Form 3160-5
(June 2019)UNITED STATES
DEPARTMENT OF THE INTERIOR
BUREAU OF LAND MANAGEMENTFORM APPROVED
OMB No. 1004-0137
Expires: October 31, 2021**SUNDRY NOTICES AND REPORTS ON WELLS**
Do not use this form for proposals to drill or to re-enter an abandoned well. Use Form 3160-3 (APD) for such proposals.

8. Well Name and No. ROSS DRAW 17 FED COM/503H

EOG respectfully requests an amendment to our approved APD for this well to reflect the following changes:

Ripple 32 Fed Com 716H (FKA Ross Draw 17 Fed Com 503H) API #: 30-015-48485

WELL LOCATION AND ACREAGE DEDICATION PLAT

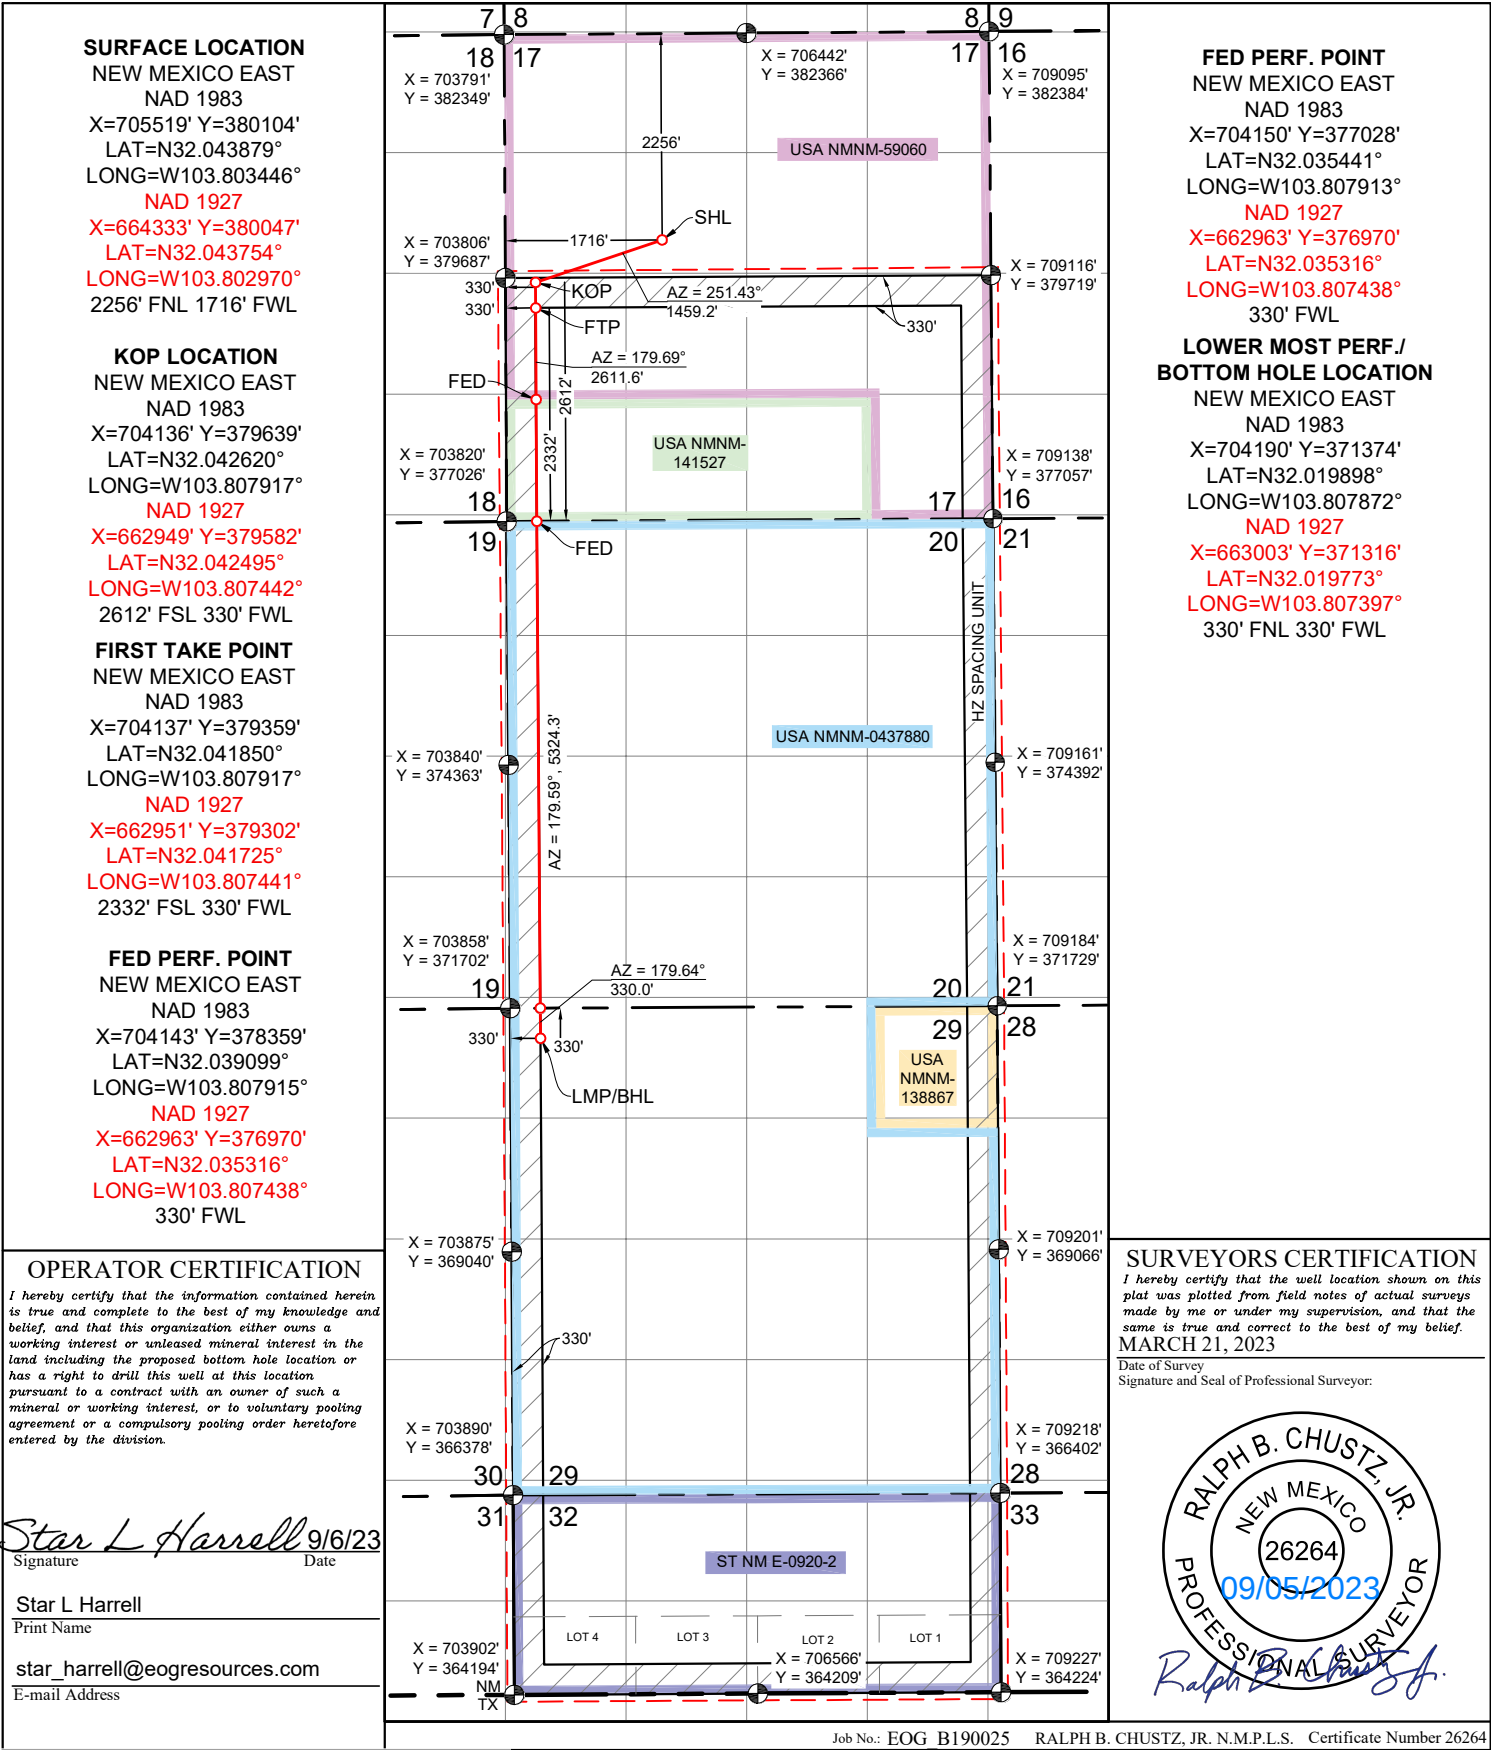
Change name from Ross Draw 17 Fed Com 503H to Ripple 32 Fed Com 716H.

Change SHL from T-26-S, R-31-E, Sec 17, 2326' FNL, 1744' FWL, Eddy Co., NM, to T-26-S, R-31-E, Sec 17, 2256' FNL, 1716' FWL, Eddy Co., N.M.

Change BHL from T-26-S, R-31-E, Sec 8, 100' FNL, 2630' FEL, Eddy Co., NM, to T-26-S, R-31-E, Sec 29, 330' FNL, 330' FWL, Eddy Co., N.M.

Update HSU to 1862 acres.

Update the Pool as reflected in the C-102.
